Corrigendum 4 dated June 03, 2021 to Tender Specification BHEL PSSR SCT 1959

Corrigendum 4 dated June 03, 2021 to Tender Specification BHEL PSSR SCT 1959 for the Pre Bid Tie Up for Civil, Structural and Architectural works for Integrated Talabira Township and associated works on Engineering, Procurement and Construction (EPC) basis at 3 x 800MW Talabira Power project, Jharsuguda, Odisha

Sub: NLCIL - Tender for "Infrastructure Work and Single Package EPC for 3x800 MW NLC Talabira Thermal Power Project (NTTPP) near Kumbhari & Tareikela villages in Jharsuguda District, Odisha, through International Competitive Bidding" – Time extension for bid submission, Reply to certain Pre-Bid Queries and Certain modification/amendment to tender document
- Corrigendum No -15 – Reg.

NTPP
SITE GRADING LAYOUT

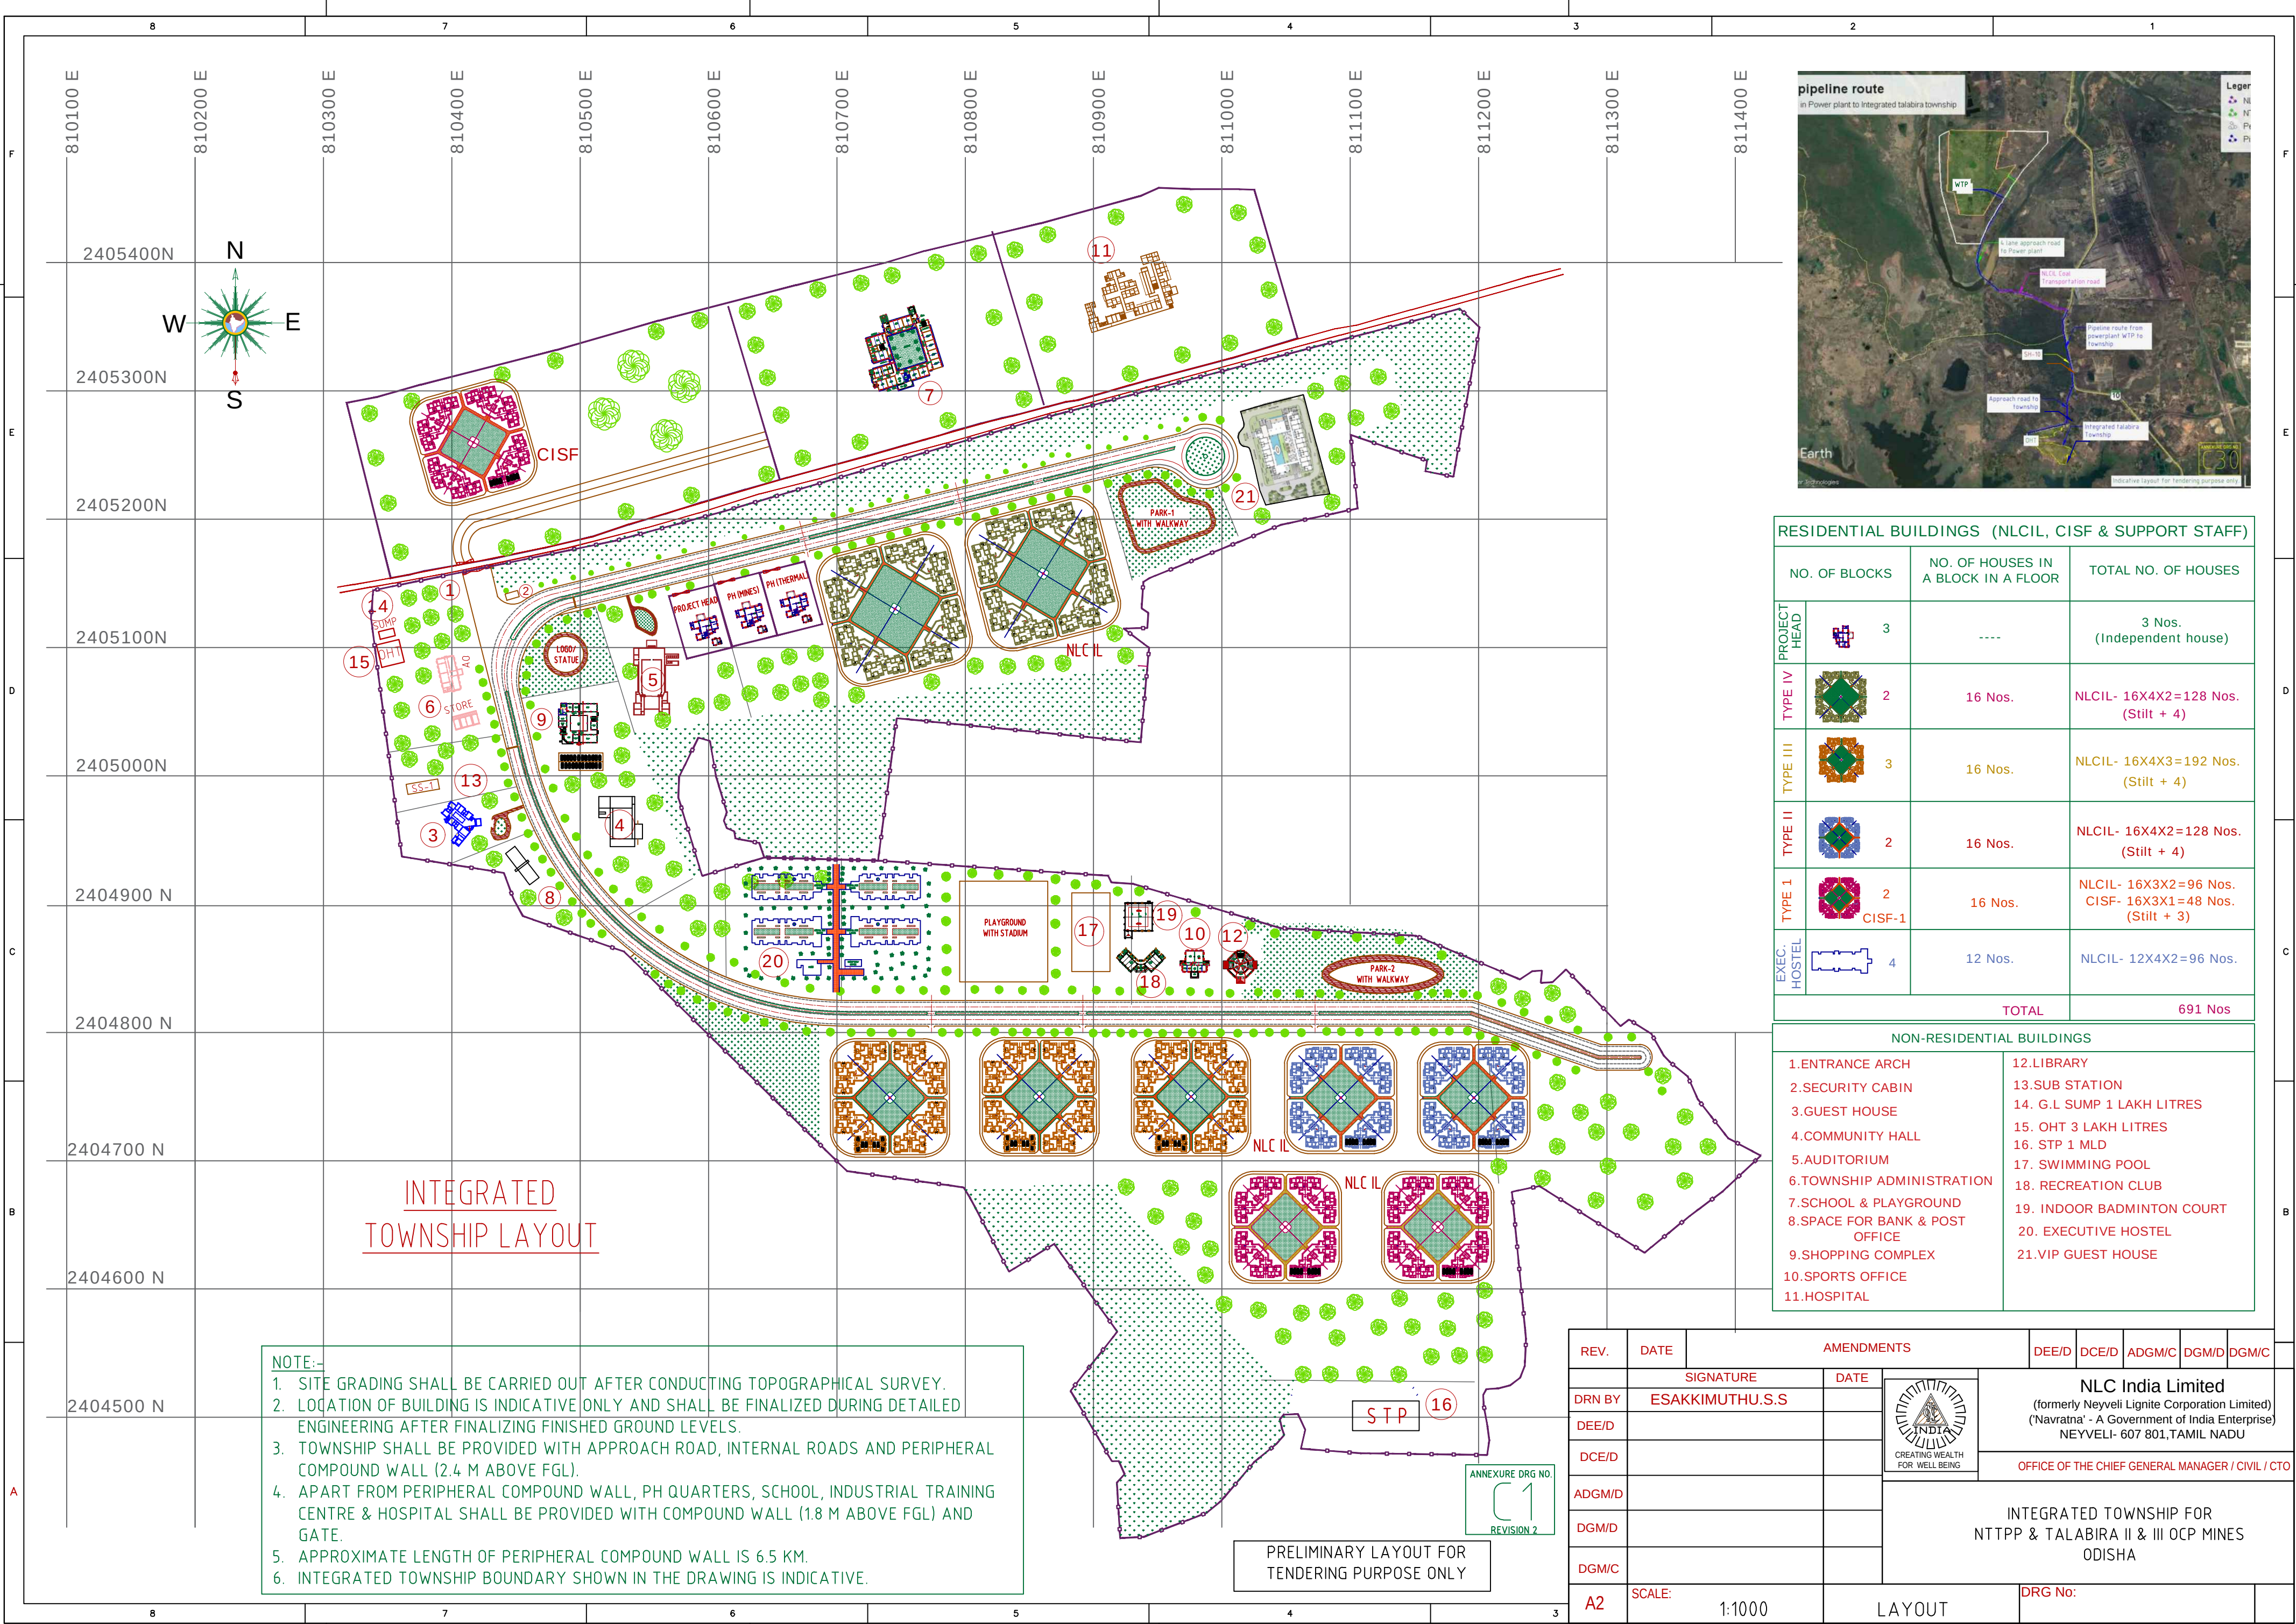
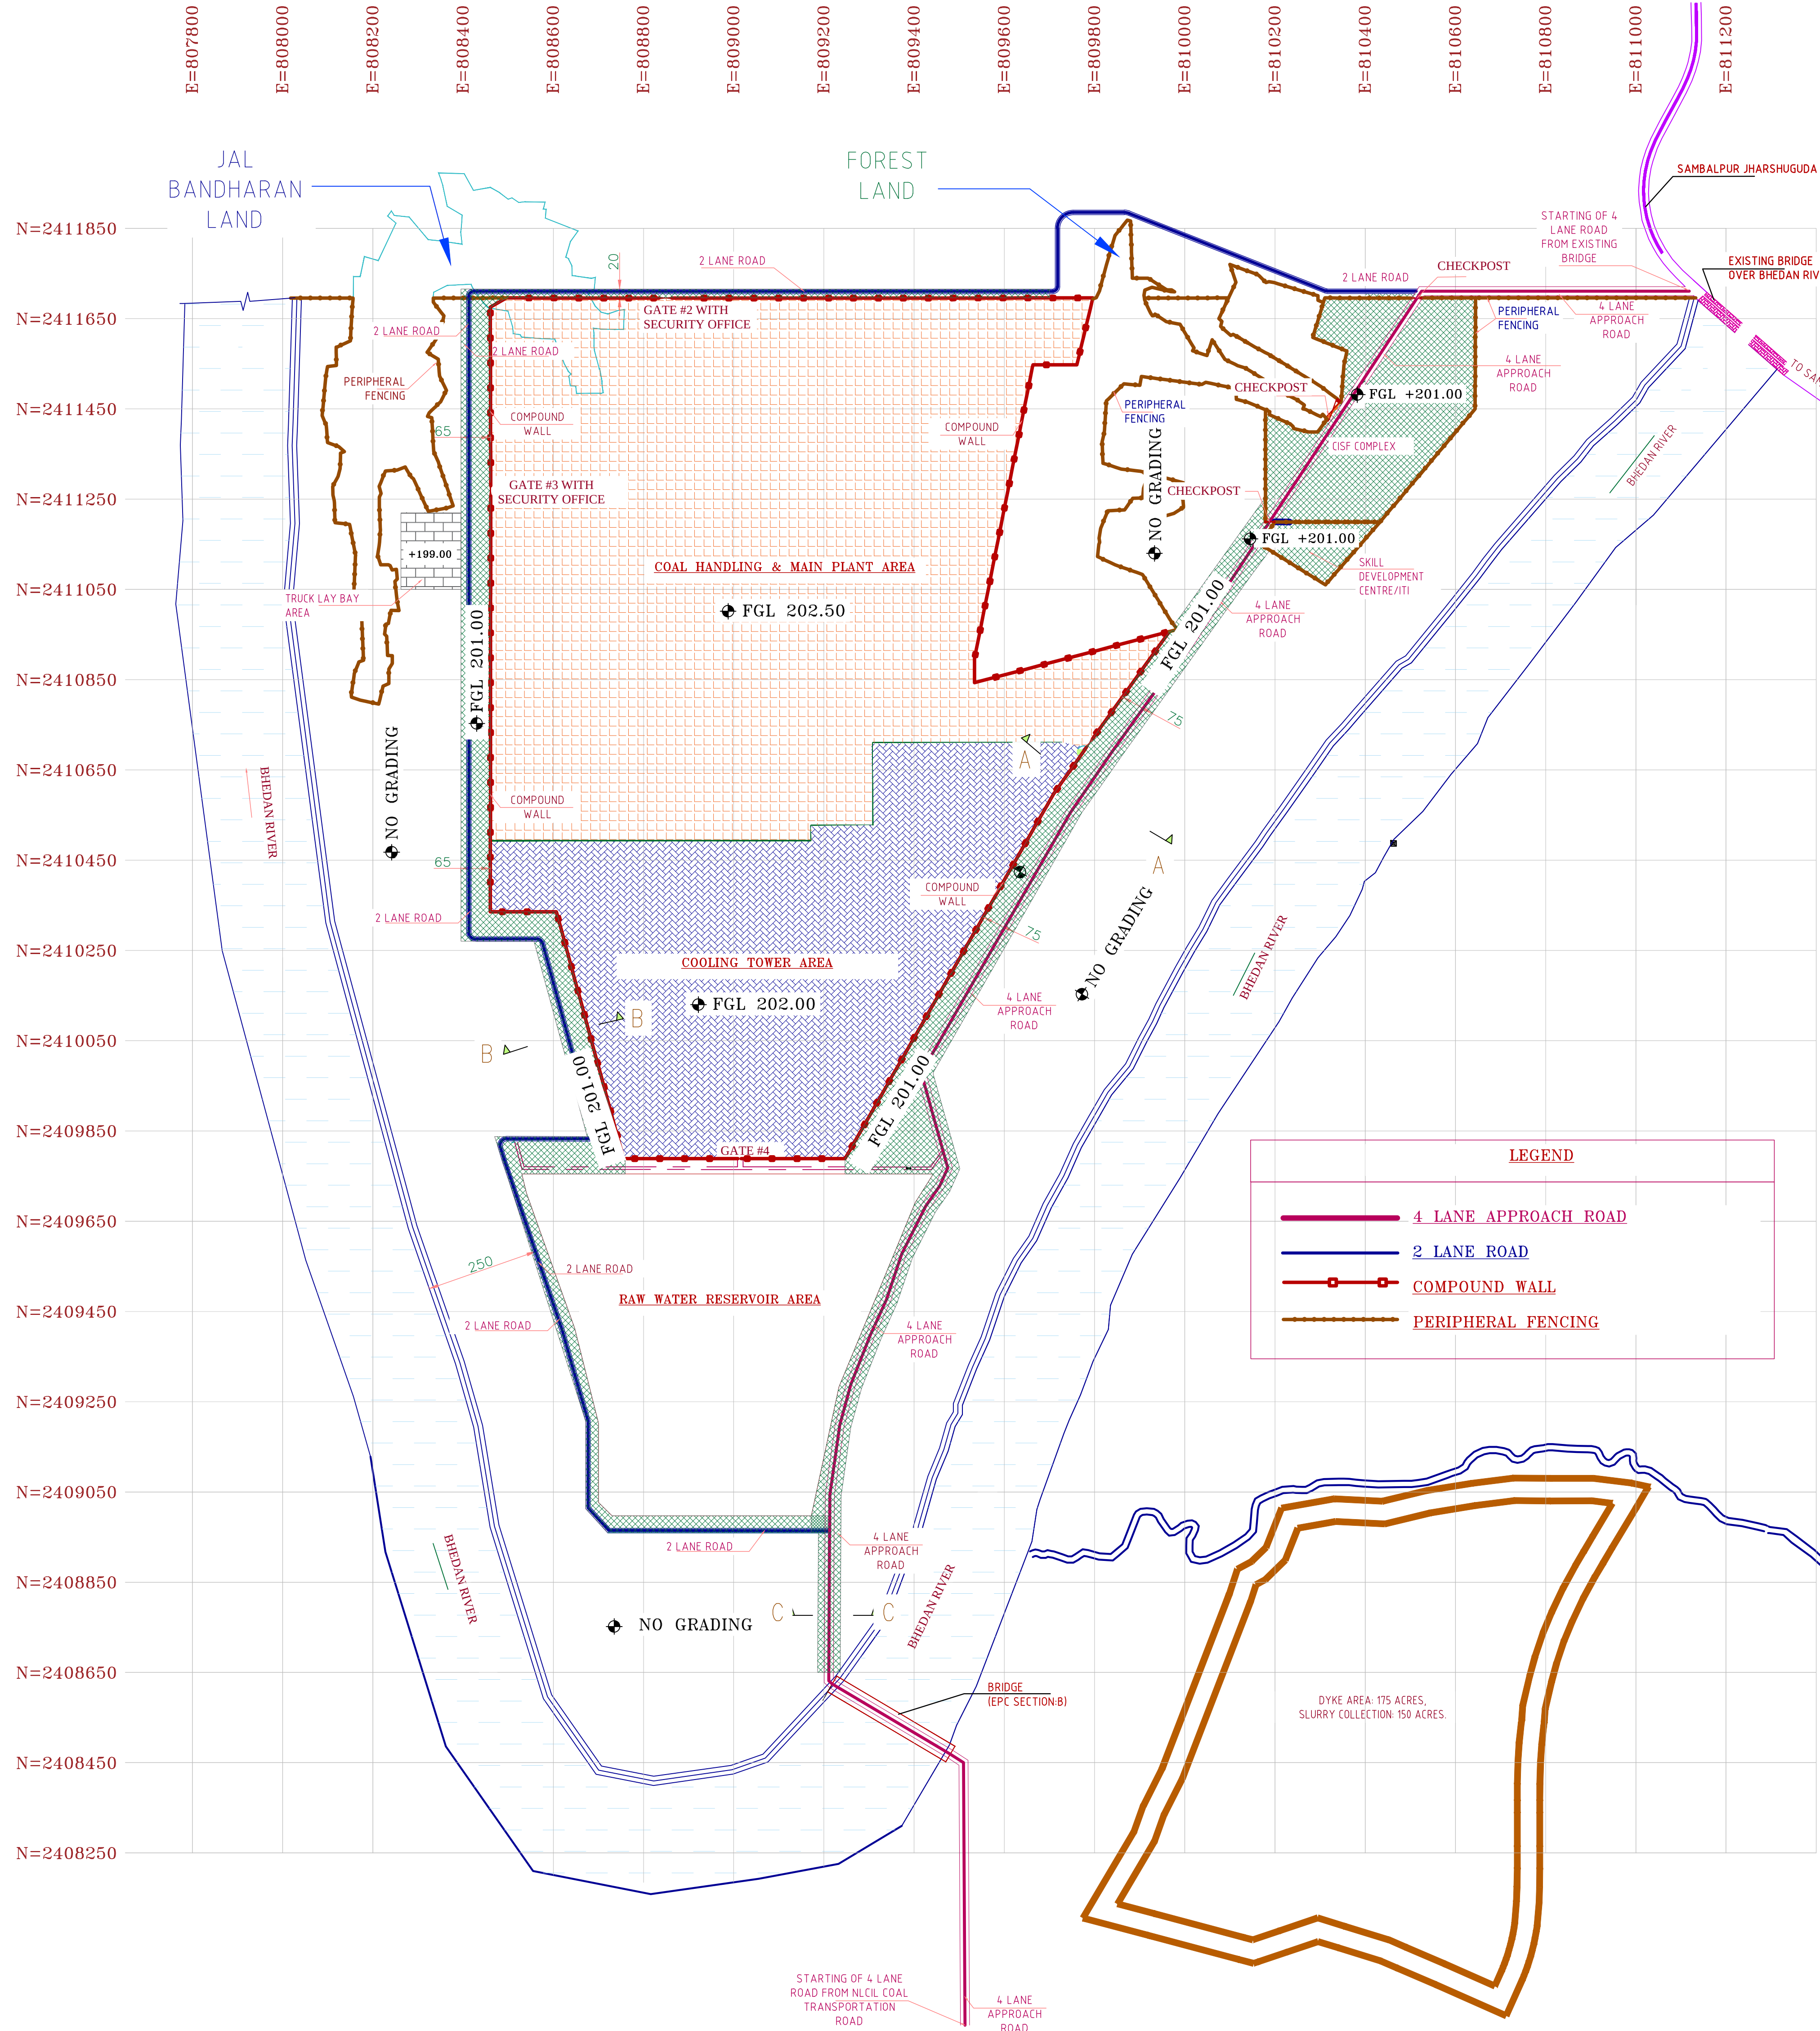
- 1) *Peripheral fencing has been:*
 - a. *Removed from 250 m boundary*
 - b. *Provided in northern side around Jal Bhandaran land, Forest land and CISF Complex**Hence, peripheral fencing length has been modified from 11.75 km to 9 kms. Number of check posts with security portacabins updated and updated Annexure Drg No. B1 (R3) attached.*

- 2) *Two lane truck road has been provided at 20 m from compound wall, instead of 50 m at Northern side.*
- 3) *Peripheral single lane village road has been removed totally. Accordingly, Drg No. B23, Sheet 1 and relevant specification deleted.*

- 6) *Site grading is added in*
 - a. *Truck lay bay area ($\approx$ 5 acres) at +199.00 on western side of power plant.*
 - b. *ITI Area located on southern side of CISF Colony +201.00*

Corrigendum 6 dtd 18-01-2021 SI No. 2	shall be fixed by EPC with approval of NLCIL. ✓ Work can be planned in phased manner to cover grading of main plant area in first phase and greenbelt in second phase, considering overall project timeline. ✓ Levels have been finalized keeping in view the Highest Flood Level (HFL) of Bhedan River and Area drainage study recommendations (Area drainage study for the power plant conducted by National Institute of Hydrology, Roorkee). ✓ Contractor shall work out grading requirements from the existing ground level to finished level as mentioned in site grading layout (Refer Annexure B1 (R2)). 	 ✓ Work can be planned in phased manner to cover grading of main plant area in first phase and utility areas in second phase, considering overall project timeline. ✓ Levels have been finalized keeping in view the Highest Flood Level (HFL) of Bhedan River and Area drainage study recommendations (Area drainage study for the power plant conducted by National Institute of Hydrology, Roorkee). ✓ Contractor shall work out grading requirements from the existing ground level to finished level as mentioned in site grading layout (Refer Annexure B1 (R3)).
